Title: 6 Channel CT Sensor Meter

Size: A4	Date: 2024-01-20	**Rev: 2.1**
KiCad E.D.A. kicad 7.0.5-7.0.5~ubuntu20.04.1		Id: 1/4

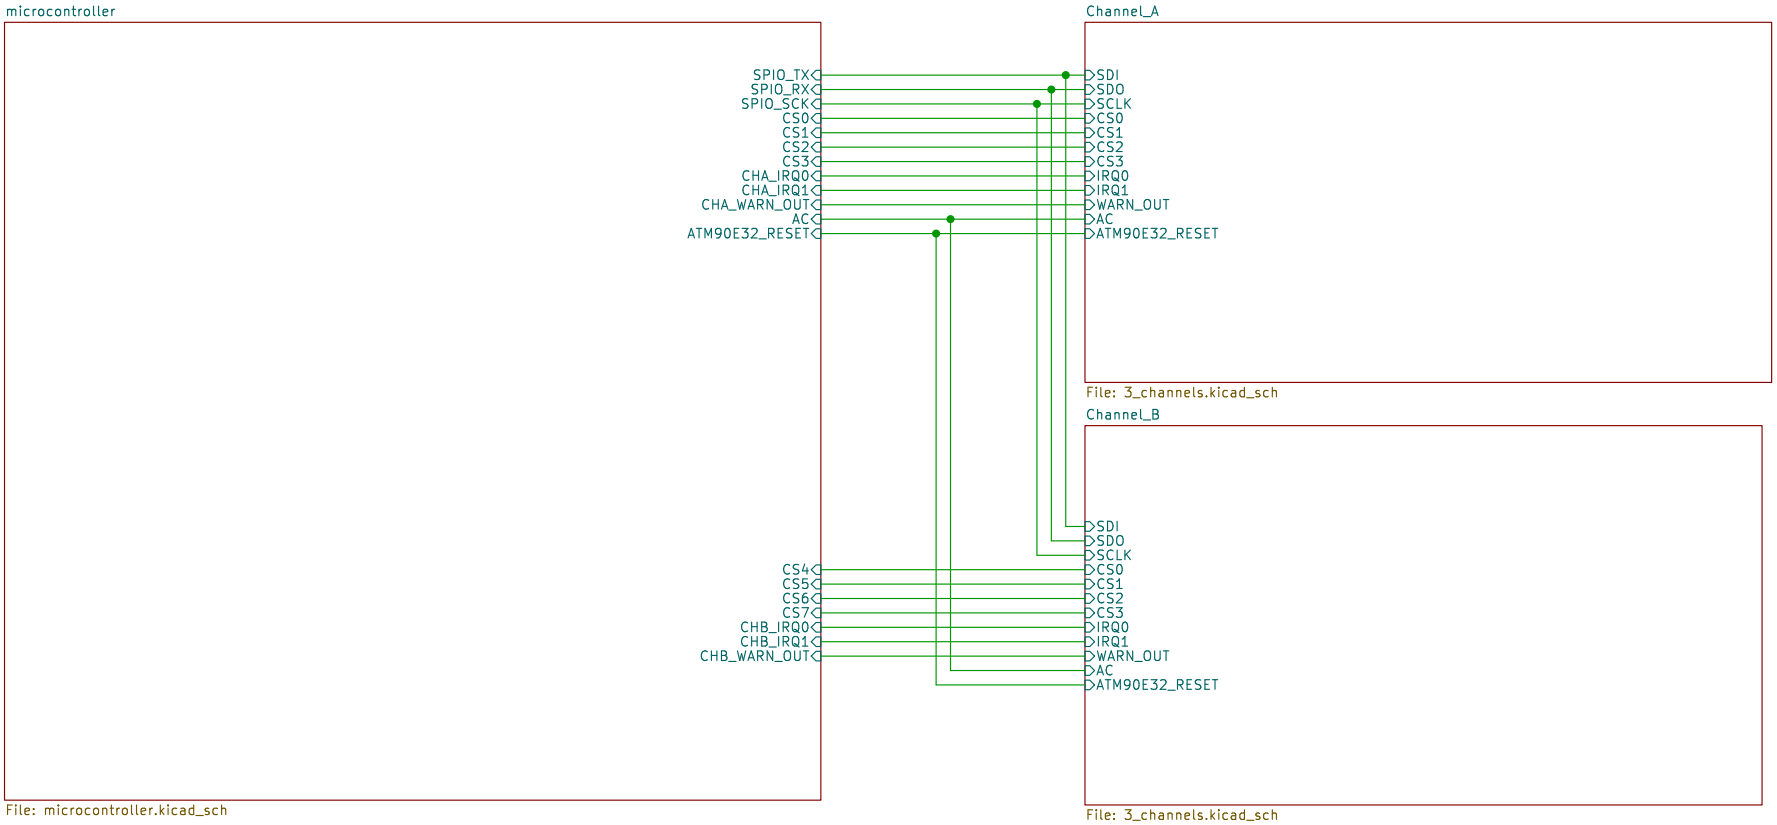
PCB Changes
2.0 – 2.1
– Connected an MCU GPIO (19) pin to reset ATM90E32 devices.

1.9 – 2.0
– 1.2mm DC power connector pin holes are now all the same size.
– Added a jumper on the PCB to allow the voltage offset to be calibrated if required.

1.8 – 1.9
– Added ability to power down the display to save power.

1.7 – 1.8
Changes thermal reliefs to ease soldering during MFG.
